UNITED STATES PATENT AND TRADEMARK OFFICE

Office Action Summary

10/782,282

BETTINELLI ET AL.

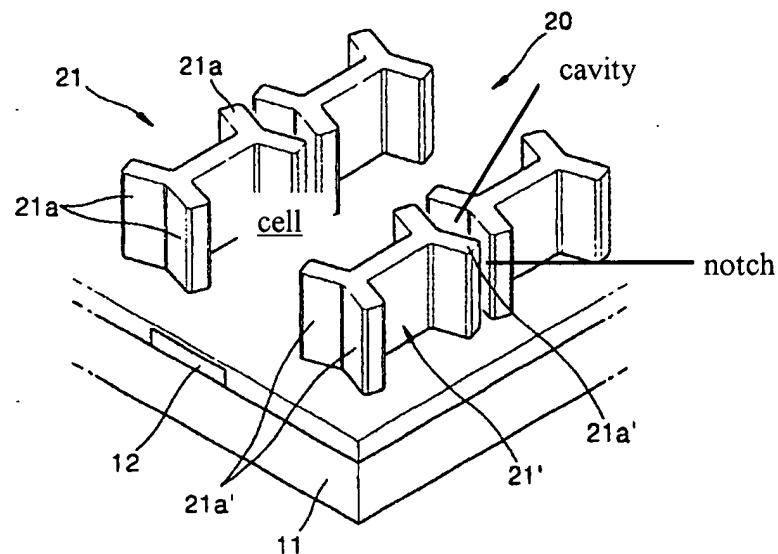
6. Regarding claim 1, Kang shows in figures 2 and 3, a plasma panel comprising two plates (40, 11) leaving a sealed space between them, which space is filled with discharge gas and is divided into discharge cells (reproduced below) that are bounded between these plates by barrier ribs (21) forming an array, the said cells being distributed in rows and columns, characterized in

that the barrier rib portion that separates any two adjacent cells of the same column includes a cavity (reproduced below) that is made in the thickness of the said rib and emerges at the top of the said rib, and also includes a notch (reproduced below) that brings the two said cells into communication with each other through the said cavity.

7. Regarding claim 2, Kang shows in figure 2 that the depth of the said cavities is greater than one third of the height of the barrier ribs.
